## NISSAN RL4FO2A AND RE4FO2A SOFT 1-2 UPSHIFT

**COMPLAINT:** Soft and/or a Slide-Bump 1-2 upshift on Nissan vehicles equipped with the RL4FO2A or the RE4FO2A transaxles.

## SERVO AND ACCUMULATOR ASSEMBLY "CUT-AWAY" VIEW

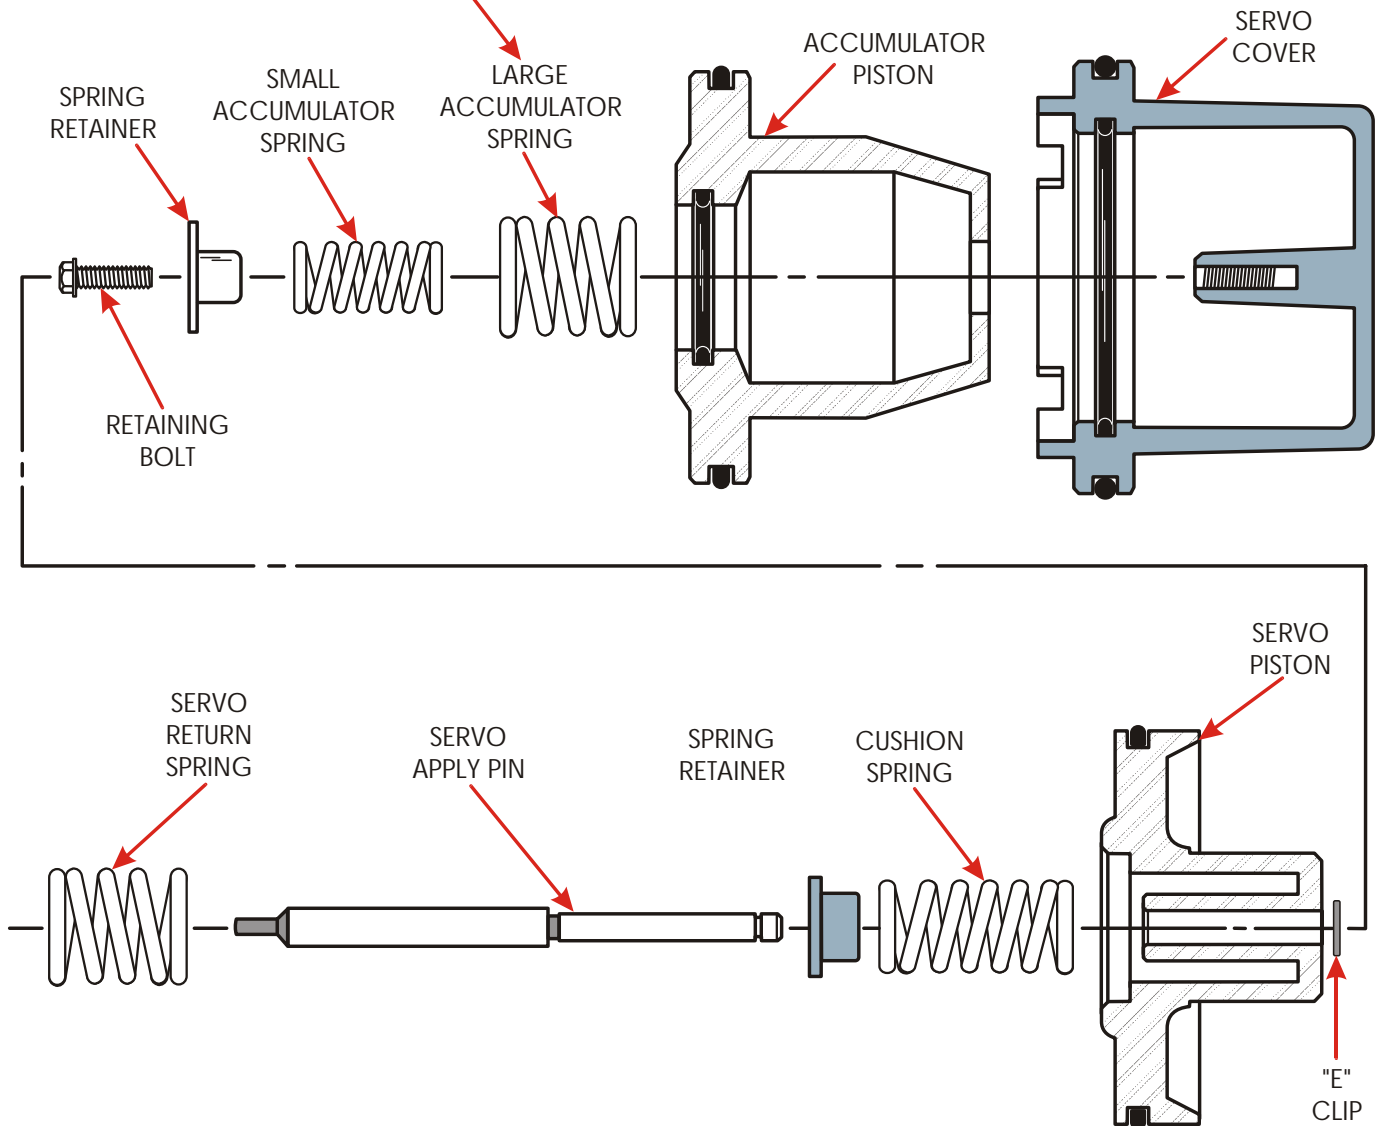
**CAUSE:** The cause may be, too much accumulator piston movement.

*For a much improved 1-2 upshift,  
remove and discard the large  
accumulator spring.*

**CORRECTION:** Remove and discard the large diameter accumulator spring as shown in Figure 2. Use the illustrations in Figure 1 and 2, to ensure proper reassembly.
